Driver and Passenger 6way Power seats –wire routing and circuit protection

Bulletin Type:	Safety Recall
Bulletin #s:	20V-600 US Units 2020-476 CN Units
Job Code:	9903521
Flat Rate(s):	RC024 1.5 Hrs. Inspect, add loom, add 2 Breakers RC025 1 Hr. Inspect and Add 2 Beakers

Publication Date:	December 04, 2020
Make:	Entegra
Models:	Aspire Anthem Cornerstone Reatta XL
Model Years:	2021

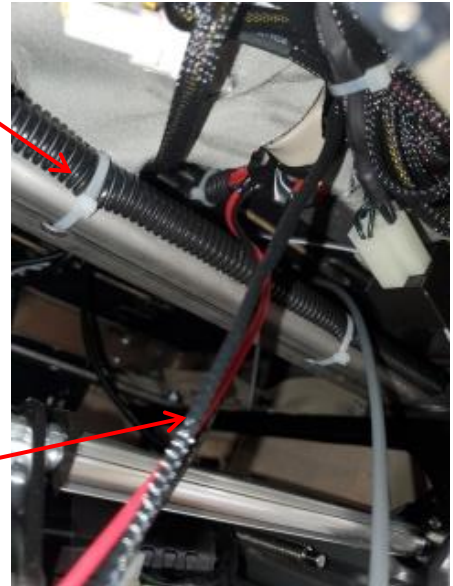
Inspect under the **driver and passenger** seats to make sure:

- The wire outside of the (wire) cluster is covered with wire loom (Picture shows the wire with loom).
- If the wire is not covered with loom, install the wire loom on both seat wires.
- The frame rail is covered with wire loom. If there is no loom on the frame piece, install the loom.

Chair Frame requires loom as shown

Wire requiring loom Shown in place

Wires require loom Shown not in place

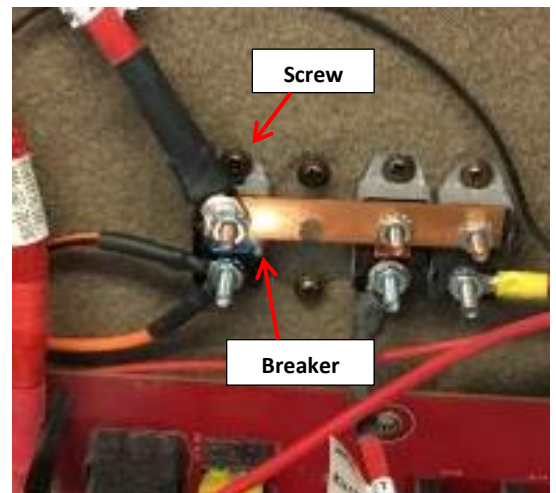
4. Locate the bus bar in the center of the compartment. Locate the (2) orange wires on the left side of the bus bar (towards the front of the unit). Using a 3/8" nut driver, remove the nut on the left wire. Remove the nut on the "feed" wire so you can access the breaker screw. Set aside both nuts for reuse.

5. Use the screw gun with the square bit, to remove the screw on the breaker (for the wire you just removed). Set aside for reuse.
6. Remove the breaker from behind the bus bar.

7. Install the new breaker where the original one was removed. The manual switch should be installed at the top.
